Objections to the Appeal Statement of Case by Carter Jonas dated March 2026

The second of these reports includes the following hydrology chart showing surface water areas:

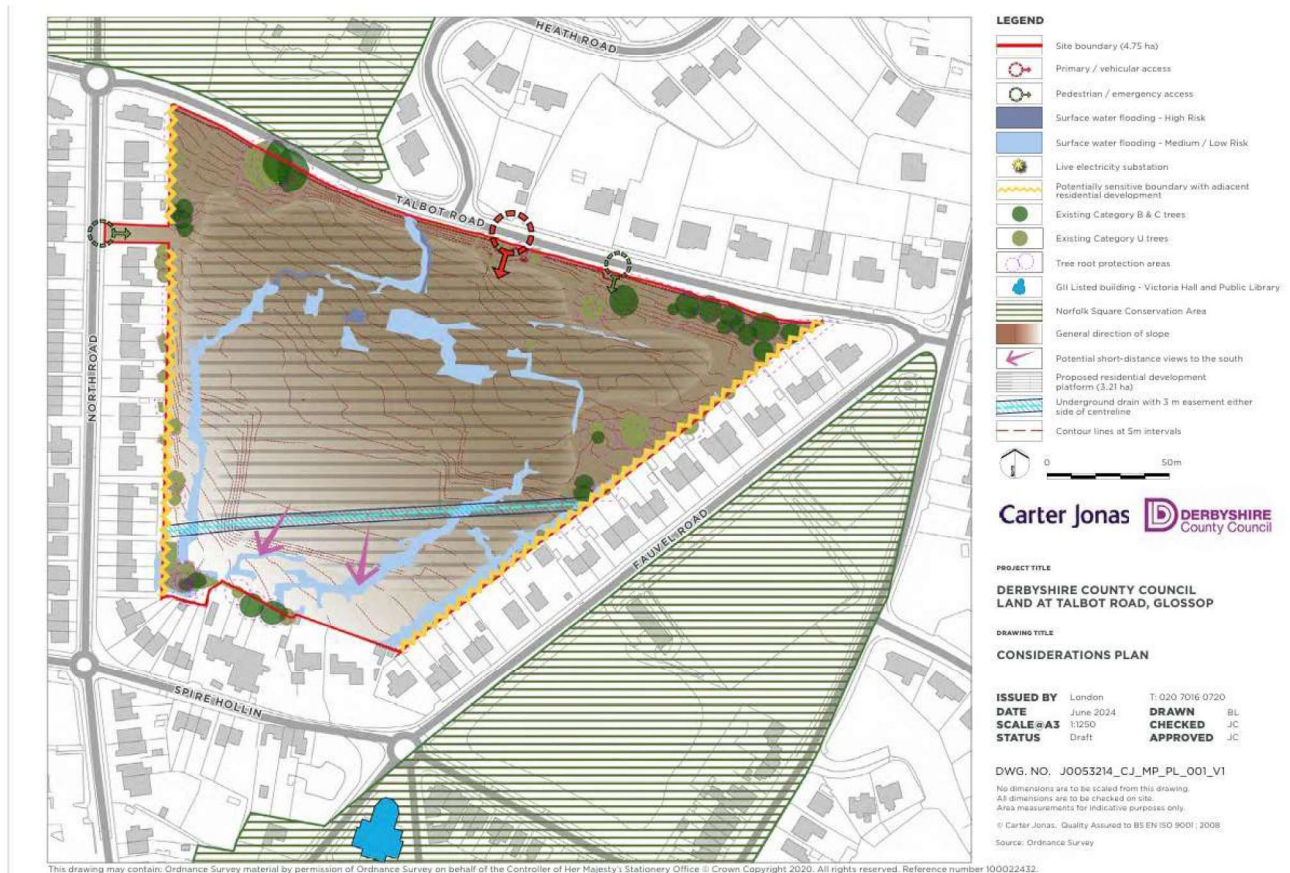
I wish to take issue in this respect with the question of drainage and the risks of flooding. The three Risk Assessment Reports (547889, 548349, and 547981) are dated August 2023 and their subsequent minor revisions do not reflect the matters in contention. Also, the included report photographs indicate that the reports were written before the former school had been demolished.

The site is located downhill of the Heath estate which in turn is downhill of at least three new housing developments spreading all the way to the summit along Cemetery Road. Much new housing infill is under development in that area and doubtless, further developments will be approved in the near future. The site therefore is situated at the lowest end of a continuous downhill development. It is well known that covering areas

of undeveloped land with tarmac and concrete drastically increases the surface water run-off rate. **Therefore, run-off rates on the site should be expected to continue increasing as a result of the new housing developments and to become more frequent and more severe as a result of climate change.** The site is already subject to periods of severe waterlogging and flooding of adjacent properties in Spire Hollin, North Road, and Fauvel Road, and has been so for the nearly four decades while I have lived in Spire Hollin. The chart shows my property as bounding the lowest point of the site and is as such the most liable to the intrusion of flood water that has an ever-increasing catchment area.
